SUNDRY NOTICES AND REPORTS ON WELLS

LOOKOUT C FED #8

30-005-64041

PIT DESIGN AND CONSTRUCTION SPECIFICATIONS (19.15.17.11)
***Pit Amendment (9/11/08)**

MCKAY OIL CORPORATION - LOOKOUT C FED #8
990' FEL & 2310' FNL, SE¼NE¼, Unit H, SEC9, T6S, R22E
API: 30-005-64041

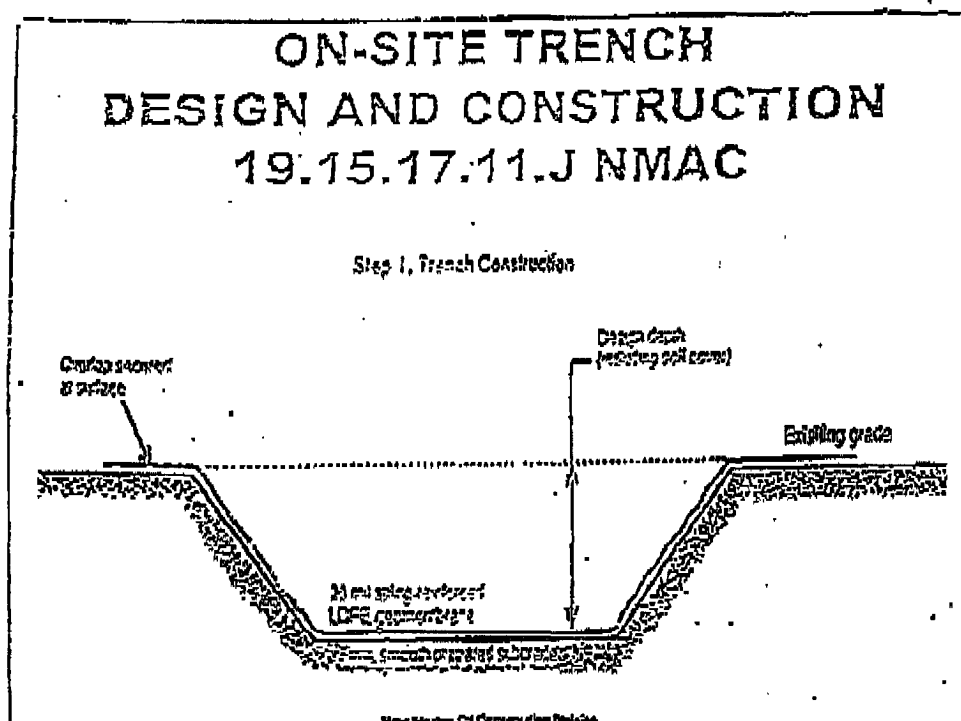
1. Any topsoil, which can sustain plant vegetation, will be bladed and piled for future rehabilitation.
2. The location slopes very slightly from the west to the east. Due to hard rock, pit will be dug to 6' depth on northeast corner and taper to 4' depth on the northwest corner.

3. The 60' X 80' pit shall be constructed and maintained so that runoff water from outside the location is not allowed to enter the pit. The berms surrounding the entire perimeter of the pit shall extend a minimum of two (2) feet above ground level. At no time will standing fluids in the pit be allowed to rise above ground level.
